## STAFF RECOMMENDATION

1507 Shelby Avenue

April 18, 2018

**Application:** New construction—Infill and outbuilding

**HOUSE ROOF PLAN**

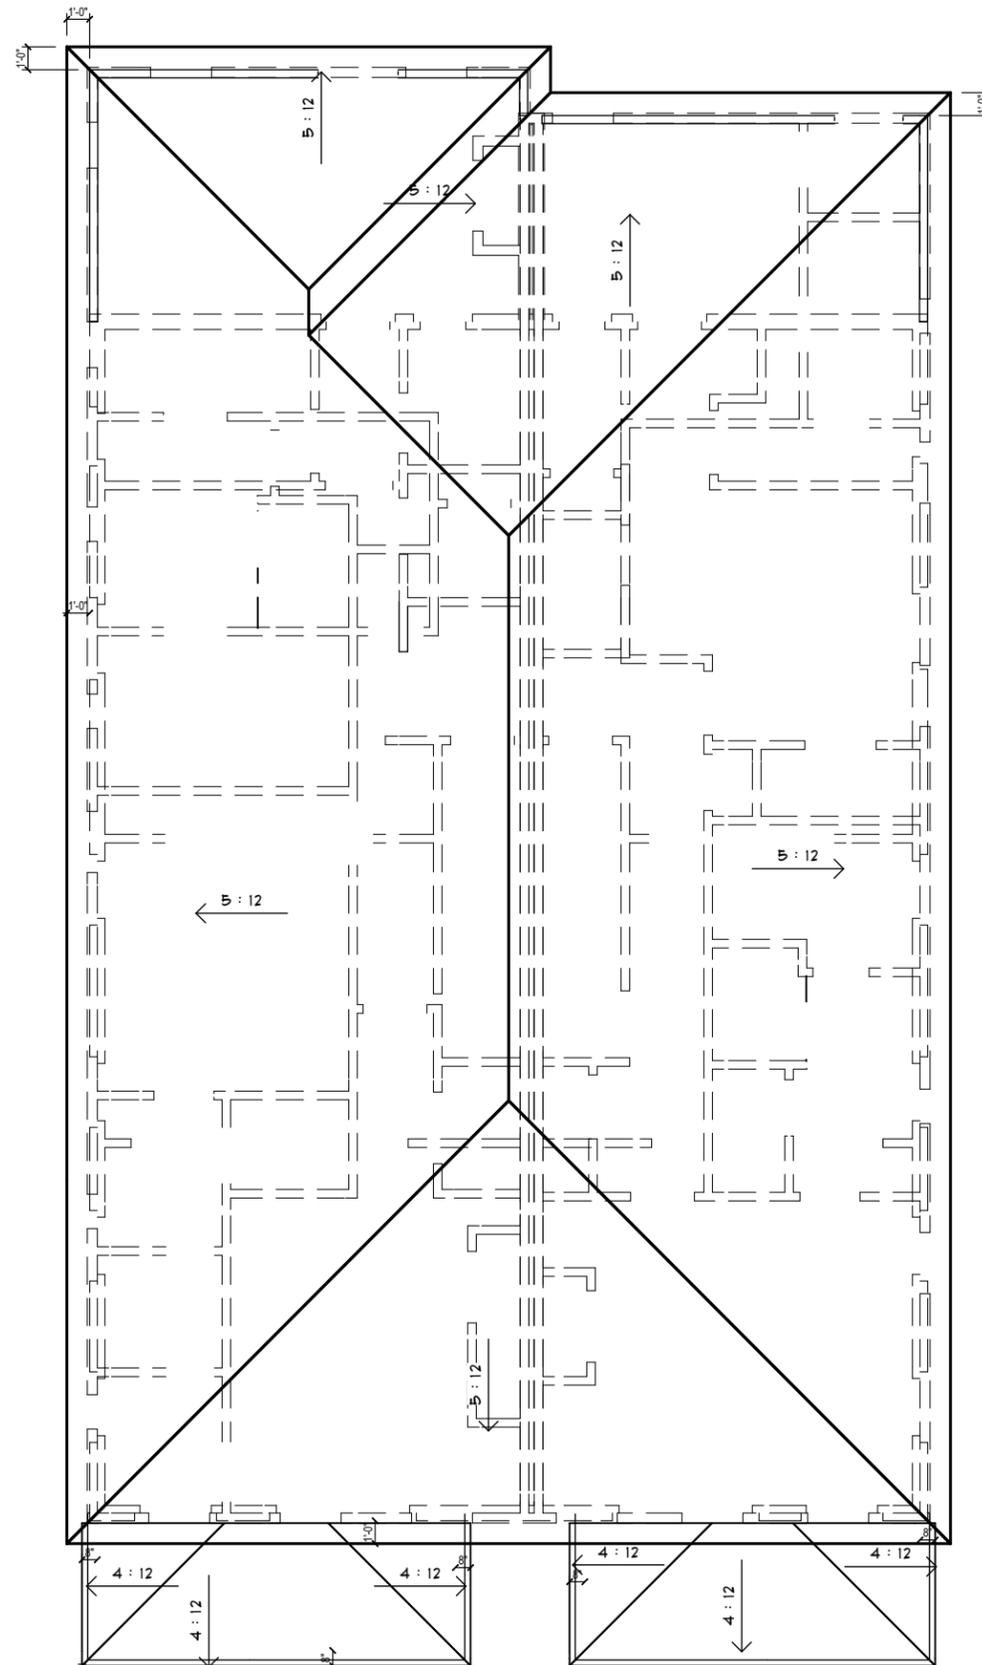
Roof form: The primary roof form is a hipped roof with at 5/12 slope. The design guidelines require that primary roof forms be a minimum of 6/12. Staff recommends that the primary roof form be a minimum of 6/12. In the revision, the height of the house should not increase and should remain at twenty-nine (29') from approximate grade. The front porch roofs are hipped with a 4/12 pitch, which is appropriate. With the condition that the primary roof slope be increased to 6/12 without increasing the overall height of the house, staff finds that the infill's roof forms to meet Section II.B.5. of the design guidelines.

1. The finished floor height be consistent with the finished floor heights of the adjacent historic houses, to be verified by MHZC staff in the field;
2. The roof slope be at least 6/12, and the height of the structure remain no taller than twenty-nine feet (29');
3. The front doors be at least half glass, and staff approve the final details, dimensions and materials of windows and doors for buildings prior to purchase and installation;
4. Staff approve a brick sample;
5. Staff approve the materials of the rear porch floor, columns, and steps; and
6. The HVAC be located behind the house or on either side, beyond the mid-point of the house.

EXISTING FRONT RETAINING WALL TO REMAIN (NOT SHOWN) **FRONT ELEVATION** ANSI B (11" X 17") 1/8 IN = 1 FT EXISTING FRONT RETAINING WALL TO REMAIN (NOT SHOWN)

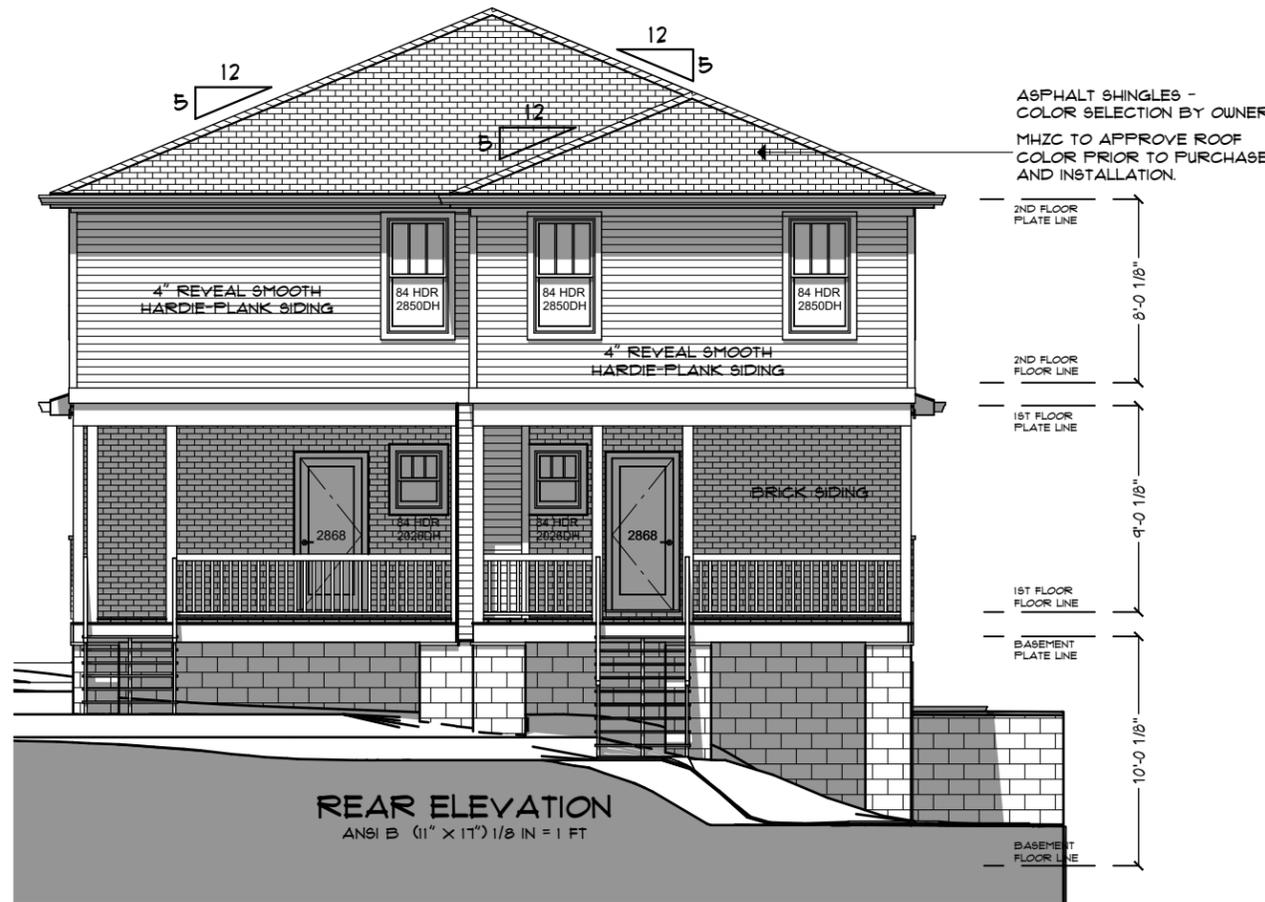
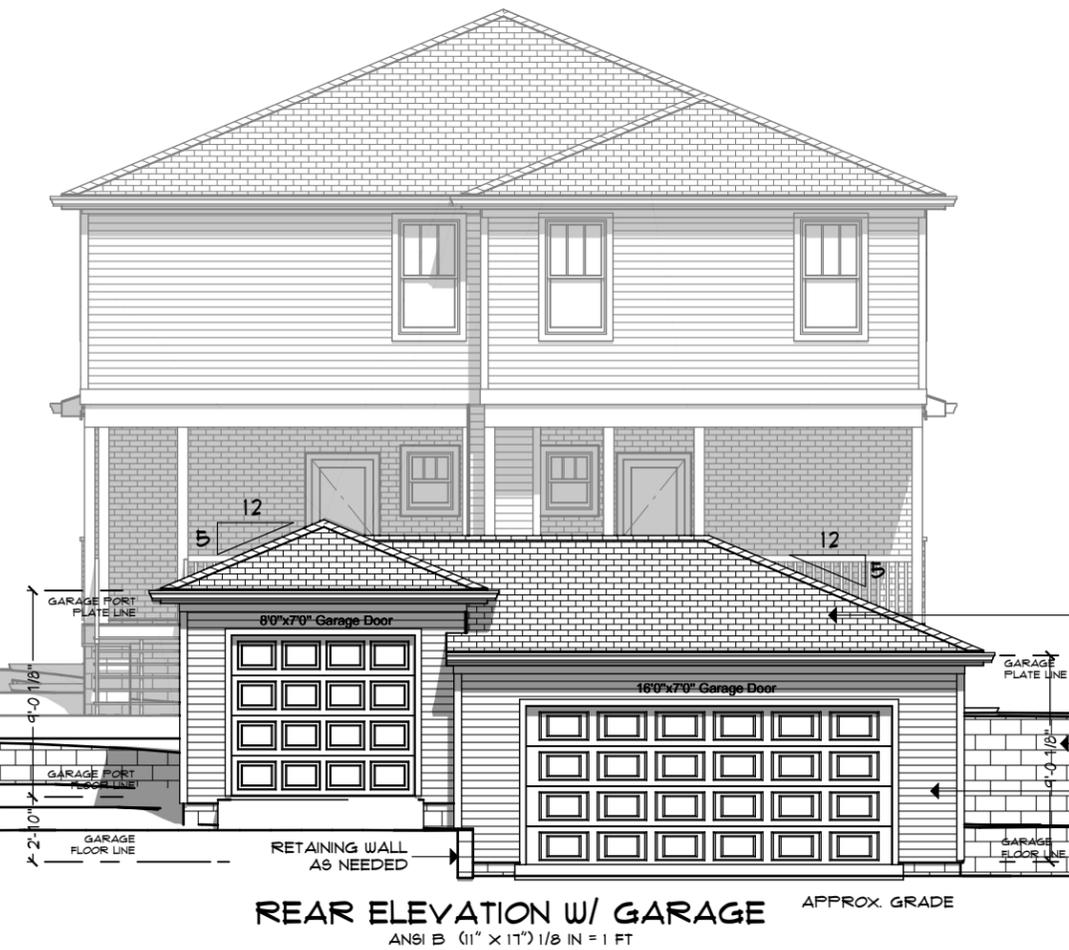
\*The proposed front doors are drawn as approximately one-fourth glass, but the design guidelines require that the front doors be at least one-half glass. Staff recommends approval of all windows and doors; a brick sample; the roof shingle color and texture; the materials of the rear porch floor, stairs, and columns; and the walkway material. With staff's final approval of all final material choices, staff finds that the materials meet Section II.B.4 of the design guidelines. The project meets section II.B.4.
